SAFETY EVALUATION BY THE OFFICE OF NUCLEAR REACTOR REGULATION  
RELATED TO AMENDMENT NO. \_\_\_\_\_ TO FACILITY OPERATING LICENSE NO. DPR-28  
ENTERGY NUCLEAR VERMONT YANKEE, LLC  
AND ENTERGY NUCLEAR OPERATIONS, INC.  
VERMONT YANKEE NUCLEAR POWER STATION  
DOCKET NO. 50-271

# DRAFT

Revision 1  
November 2, 2005

Fig. 2: Break Mass Flow Rate vs Time

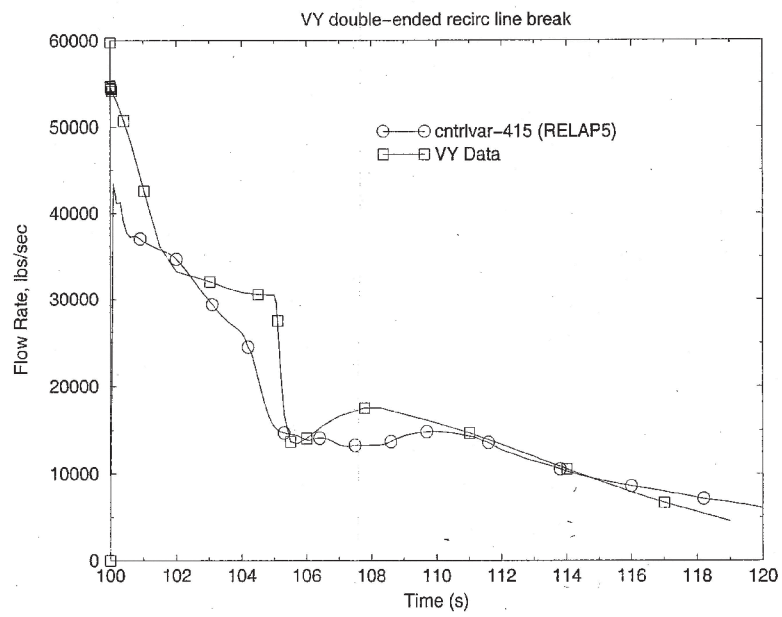
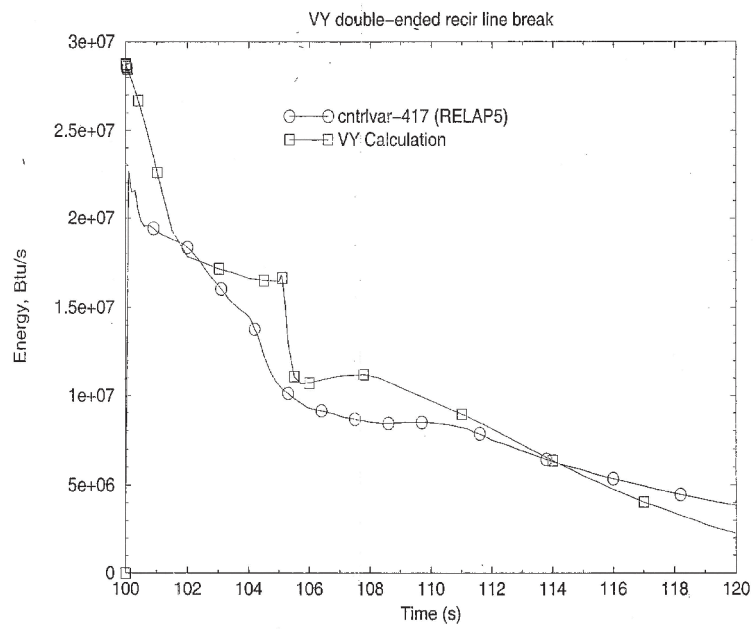
Figure 2 presents the mass flow rate from the break in the suction line. This flow rate consists of the break flow exiting both sides of the double-ended guillotine break in the recirculation line. To model the double-ended break, the break junctions are located at the exit to volume 304 and the inlet to volume 306 in Figure 1. The Henry-Fauske critical flow model in the RELAP5/MOD3 code was activated to predict the break flow. Inspection of Figures 2 and 3 shows that the RELAP5 code confirms the conservative nature of the VYNPS calculation at EPU conditions.

Figure 2.8.7-7  
Void Reactivity Coefficient vs. Instantaneous Void Fraction at an Exposure of 0 Gwd/t

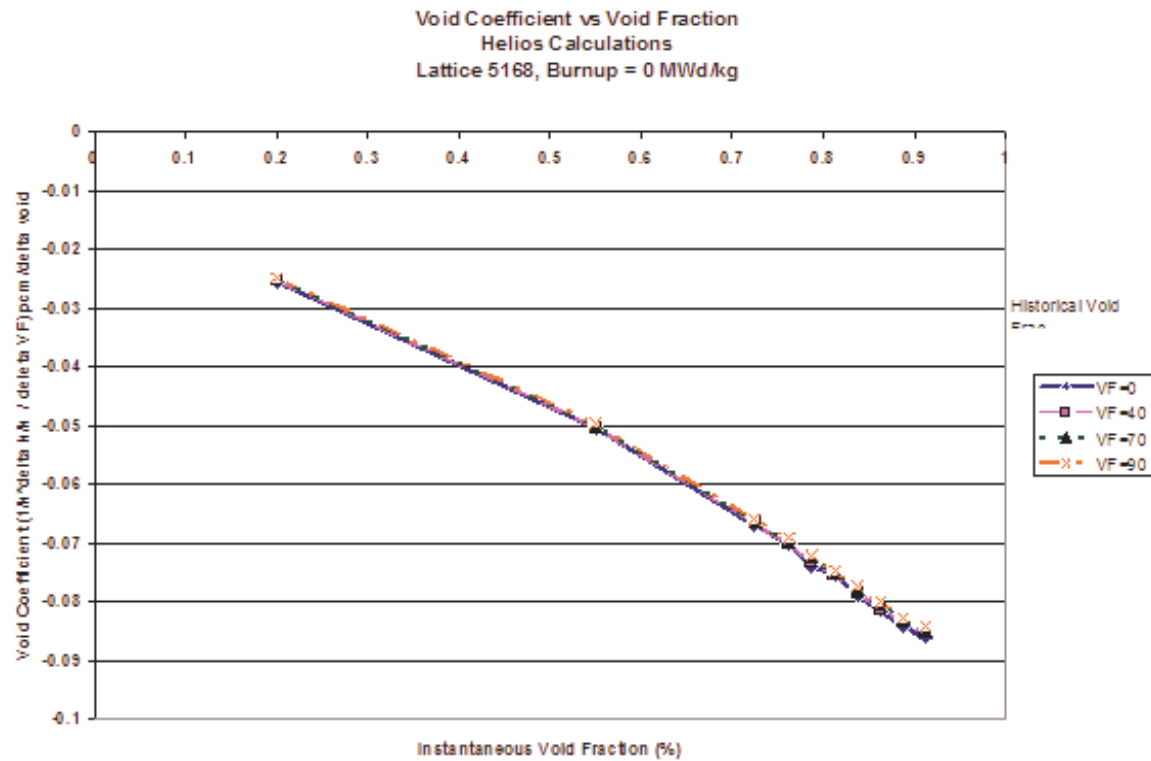
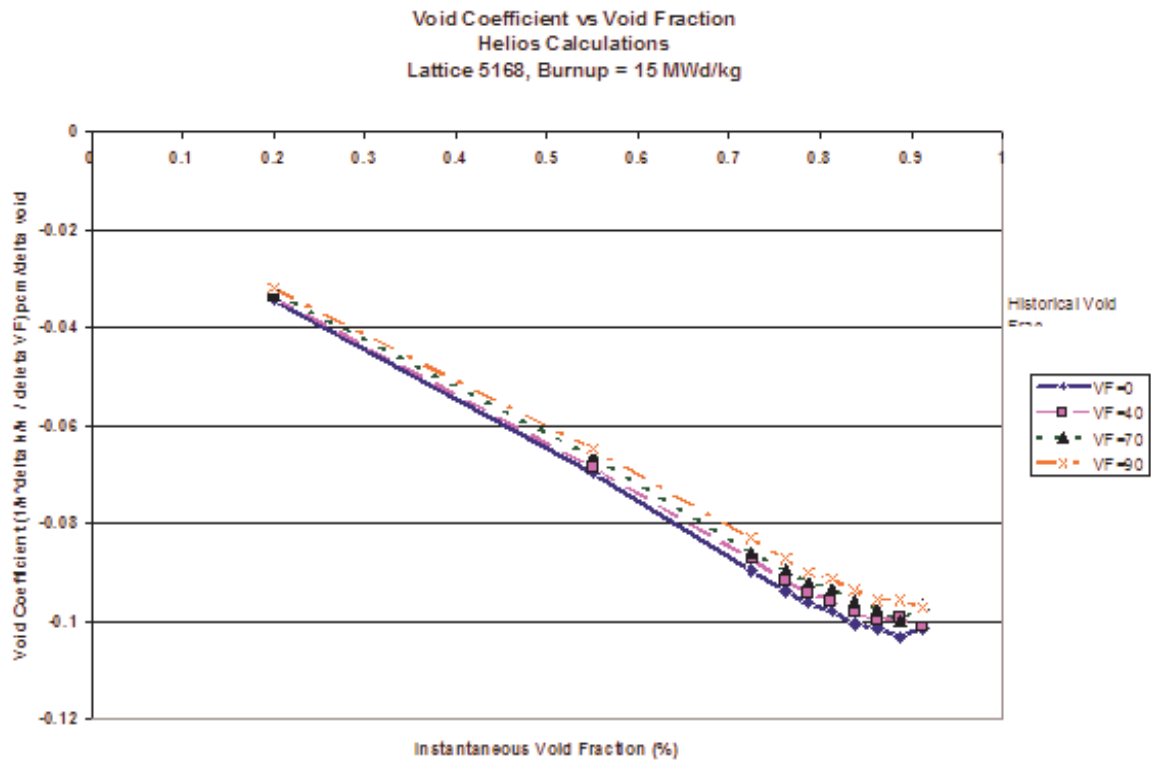
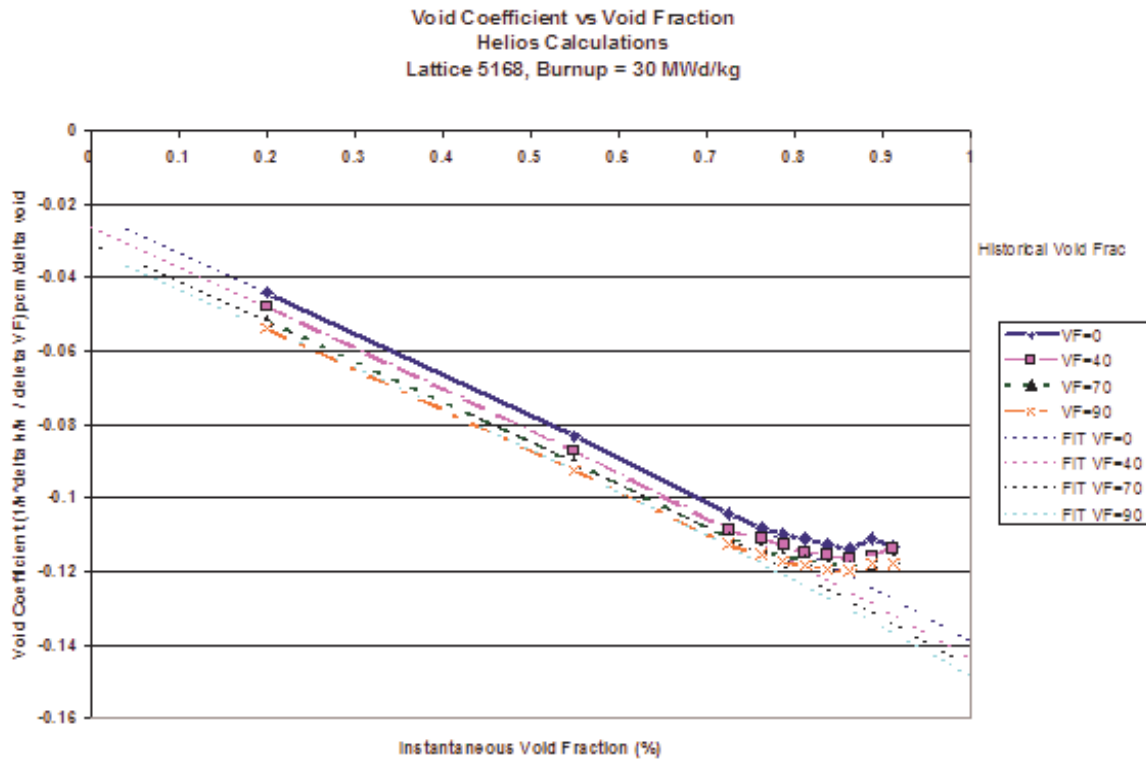
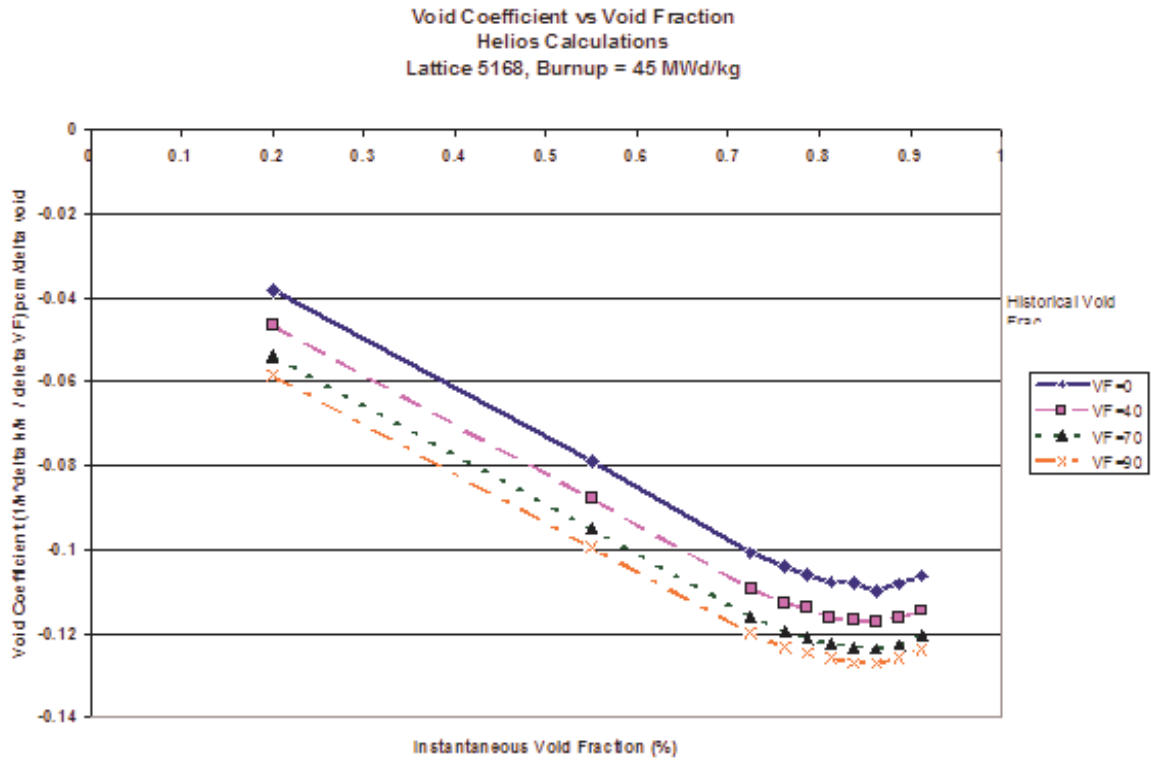
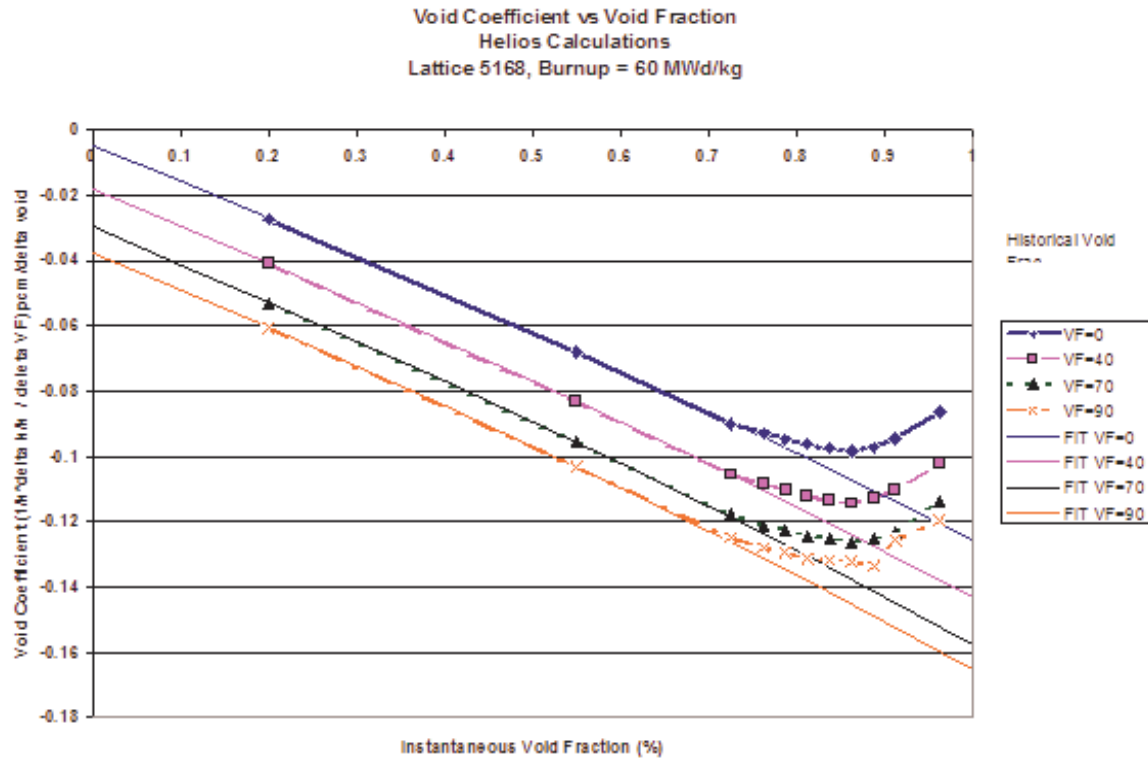
The comparison of the void reactivity coefficients for the different void history cases and exposures are presented in Figures 2.8.7-7 through 11. Note that additional instantaneous branch points were calculated at the higher void conditions to resolve the non-linearity of the void coefficient with respect to instantaneous void fraction at high burnups. The impact of the different void histories are evident at the higher void fractions with the increasing difference in the void reactivity profiles with increasing exposure (see Figure 2.8.7-11, for example). The difference in the profiles from that at a void history of 40% represent a potential error resulting from GE's methodology. In addition, the deviation of the void reactivity from a linear variation represents an error that results from the quadratic extrapolation used in GE's methodology. As shown in these figures, at high void fractions and high exposures the profile deviates from linear.

An evaluation of the potential error in GE's methodology has been performed by comparing the void reactivity coefficients obtained using the GE approach (quadratic fitting and instantaneous void branches only at 40% void history). A plot showing the potential errors is presented in Figures 2.8.7-12 through 2.8.7-16. These figures show that the fitting process results in increasing errors with exposure and burnup (as previously discussed based on the void reactivity coefficient plots). The errors for exposures of about 30 GWd/t and less are consistent with the [[ ]] uncertainty assumed in the ODYN analysis. However, for higher exposures at high void fractions the error increases to more than 30%.

Figure 2.8.7-19  
Comparison of TGBLA-6 and CASMO-4 Kinf Values for Lattice 6996

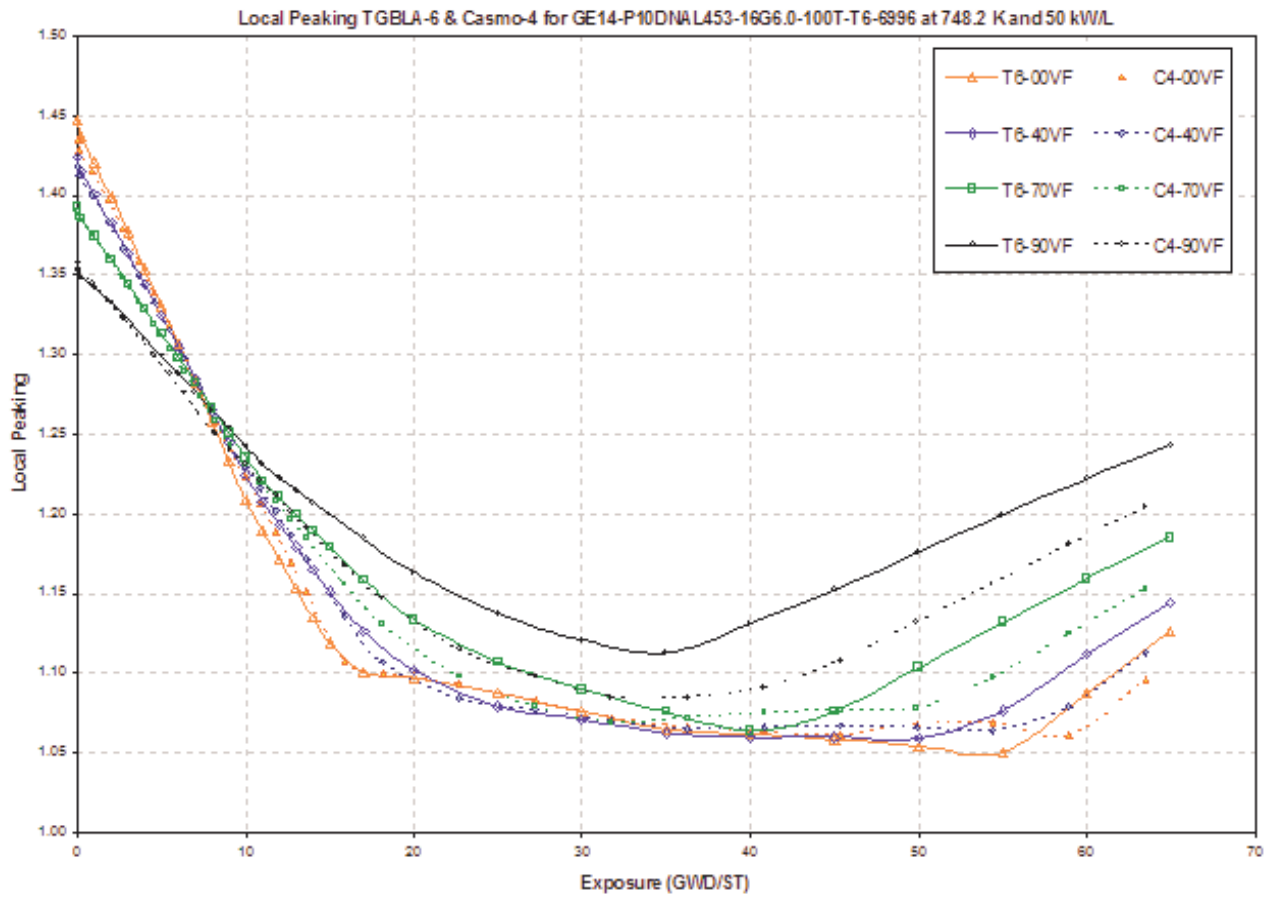
Figures 2.8.7-19 and 2.8.7-20 provides two  $K_{inf}$  vs exposure curves for historical void fractions of 40% and 70%. The calculations were performed with an instantaneous void fraction of 0%. Therefore, the difference at high exposure is caused by differing isotopic compositions resulting from the depletion at different void histories. As these figures show, the impact of void history at high exposures is significant (greater than 5% delta k). Confirmatory analyses performed with HELIOS, presented in Figure 2.8.7-21, show a similar trend and includes data for a historical void fraction of 90%.

Figure 2.8.7-22  
Comparison of TGBLA-6 and CASMO-4 Local Peaking for Lattices 6996

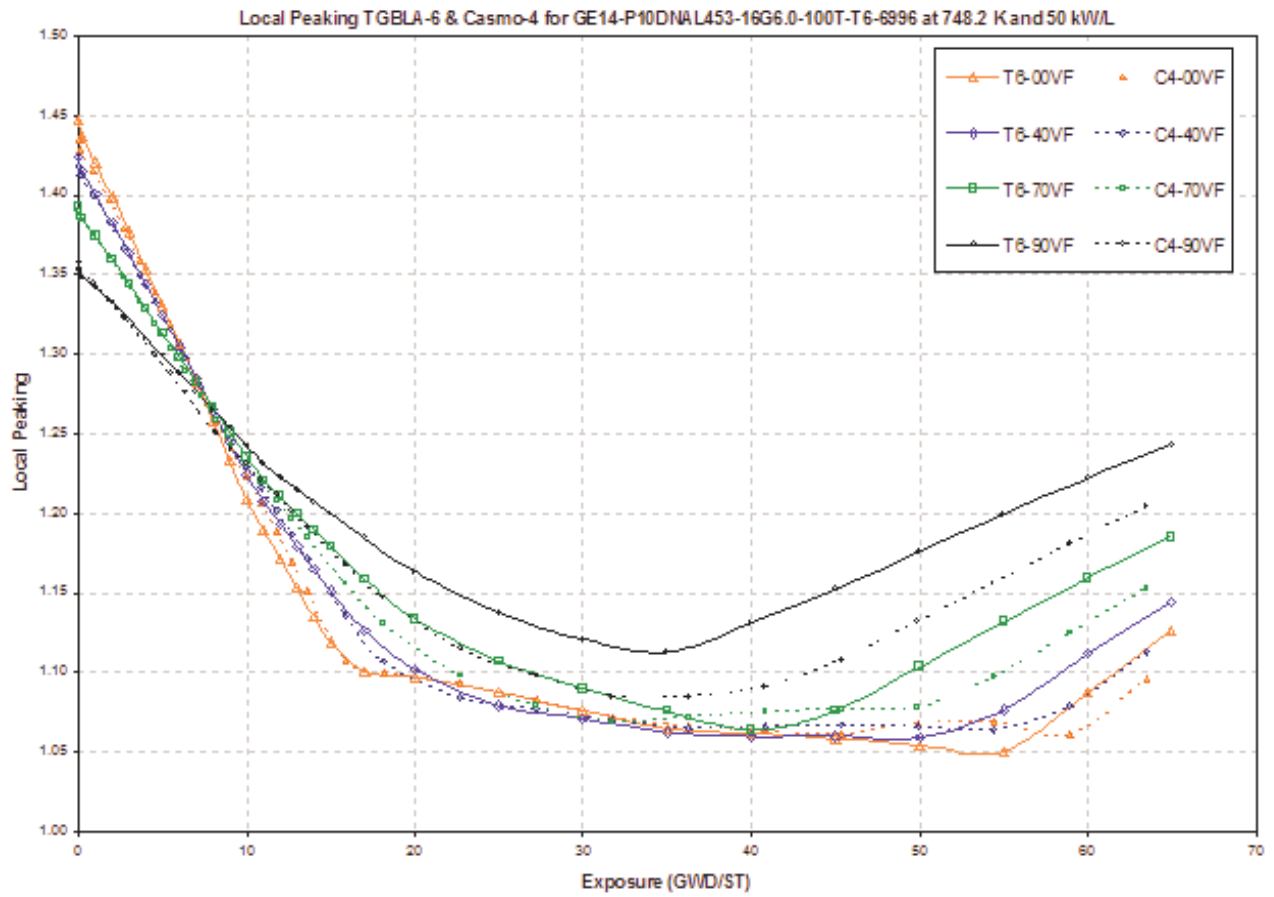
The pin peaking factor (Figure 2.8.7-22) shows good agreement at zero exposure, when the power peaking is the most significant. Differences increase with exposure resulting in several percent at burnups of 60 GWd/st. Generally, the TGBLA-6 local peaking factors are larger than CASMO-4 and therefore will be more conservative in regards to pin exposure and LHGR. Note that at high exposures (greater than 30 GWd/st) the power peaking is the largest for bundles

Figure 2.8.7-23  
TGBLA-6 / CASMO-4 RMS of Lattice Pin Power Peaking

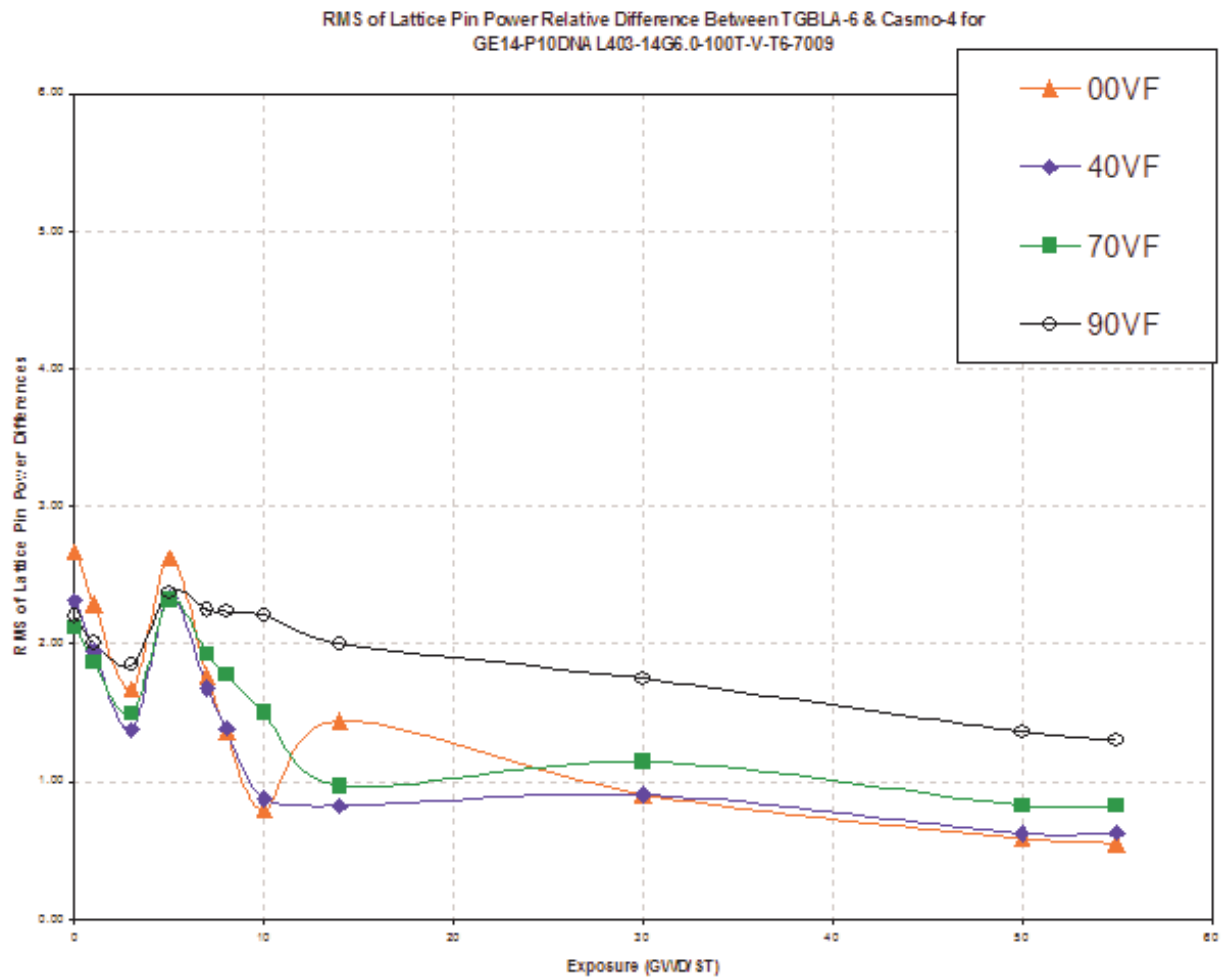
Figure 2.8.7-23 shows the root-mean-square (RMS) of the differences between TGBLA-6 and CASMO-4. The RMS error is used in development of the SLMCPR. Previous analysis comparing TGBLA-6 and MCNP (Reference 69, Enclosure 3) had shown that for a variety of lattices and exposures, that the RMS difference is [ ] However, in these comparisons the isotopic concentrations were taken from TGBLA and used in MCNP and therefore, errors in depletion were not included. The results in this figure show that on a code-to-code basis that for the lower void fractions the RMS difference at low exposures and at high void fraction exceeds the [ ] RMS value, with maximum differences of about 2.5%. For the burnups above the gadolinium burnout and for lower void fractions, the differences are consistent with the [ ] value. Note that the results for the 90% void fraction presented in Figure 2.8.7-23 does not include potential errors caused by the quadratic fit and extrapolation used in GE's neutronic methods. The results presented for TGBLA-6 are also for the corrected version of the code, as discussed below.

Figure 2.8.7-24  
Comparison of TGBLA-6 and CASMO-4 Coolant Void Reactivity Coefficients

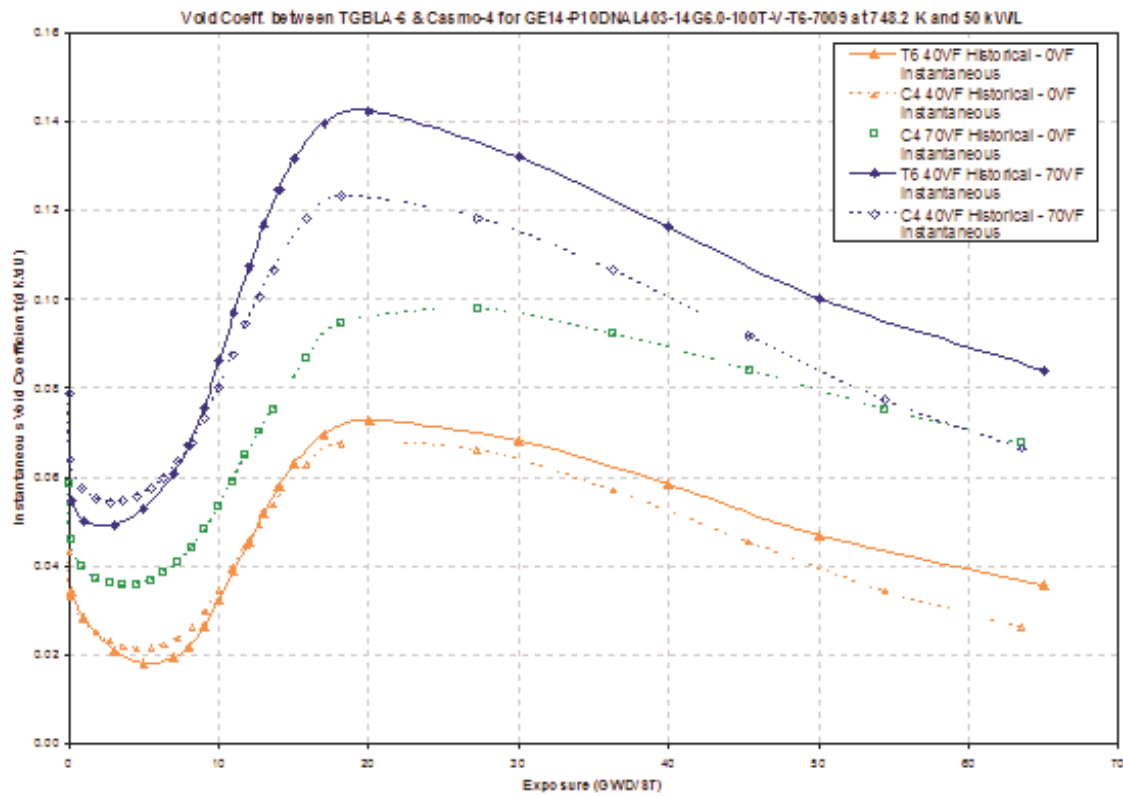
The void reactivity coefficient is an important parameter for predicting the transient response and stability of the reactor core. Comparisons of TGBLA-6 and CASMO-4 values of the void reactivity coefficient were compared in the RAI 66 response and are provided in Figure 2.8.7-24. The comparisons show that the agreement between the two codes is within the 15% assumed in the ODYN perturbation analysis. More significant is the large difference in the value of the void reactivity coefficient for the two different void histories used in the calculations (40% and 70%). The TGBLA/PANACEA neutronics methodology computes such instantaneous effects only for the 40% void history case. This assumption can lead to large errors in the evaluation of the void reactivity coefficient at high void fractions and high exposures. An evaluation of the impact of these errors was provided earlier.
